Date: 06.04.21
Project: Anarene/Double L
City of Dripping Springs
Parkland Dedication Plan

MEMORANDUM

This memo serves as follow-up correspondence to the May review by LUCK Design Team, LLC of the Anarene/Double L Parkland Dedication Plan. Please reference Parkland Dedication Plan Narrative and site plans.

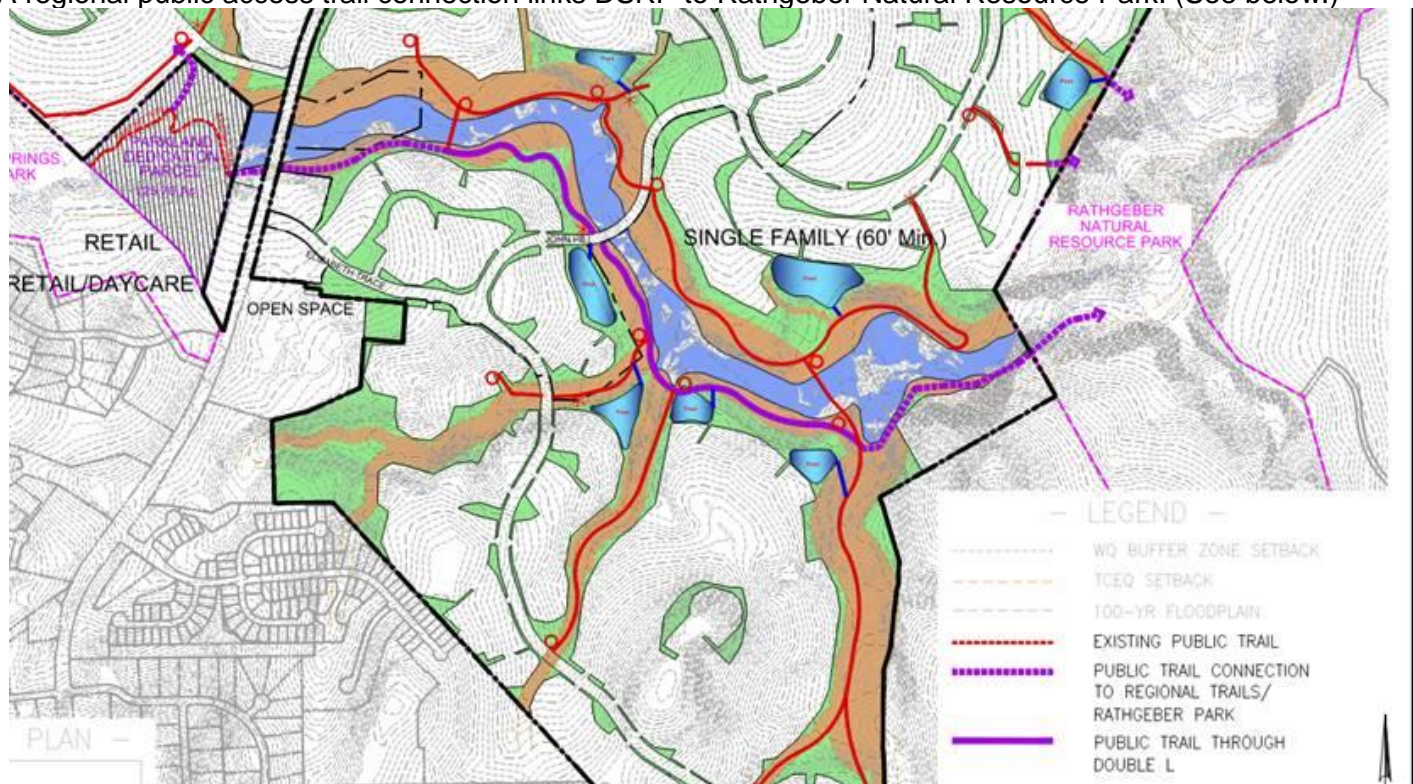
6. A regional public access trail connection links DSRP to Rathgeber Natural Resource Park. (See below.)

As currently proposed, the solid purple "Trail" will double as a maintenance road and would be developed/constructed by the Developer. Per the developer, the dashed purple public trail (on the west end connecting to DSRP and on the east end potentially connecting to Rathgeber) would be the responsibility of the City to develop if the City wants to develop.

parkland development fee of \$762,048. However, the developer would like to partially offset the parkland development fee by incorporating the value of the developer portion of the public trail (the solid purple public trail). The impact of this value is based on the following assumptions:

An 8' wide trail of 6" decomposed granite trail over 6" of compacted road base. The developer estimates the trail length to be 4,008 linear feet @ \$60/lf = \$240,500.

The value of the purple dashed trails that the City would be responsible for developing and constructing is approximately \$264,000. The developer estimates the total trail length to be 4,400 linear feet @ \$60/lf. This trail length includes both the connecting section to DSRP and the trail section to Rathgeber Natural Resource Park. The trail length is approximately equal for each trail sections.
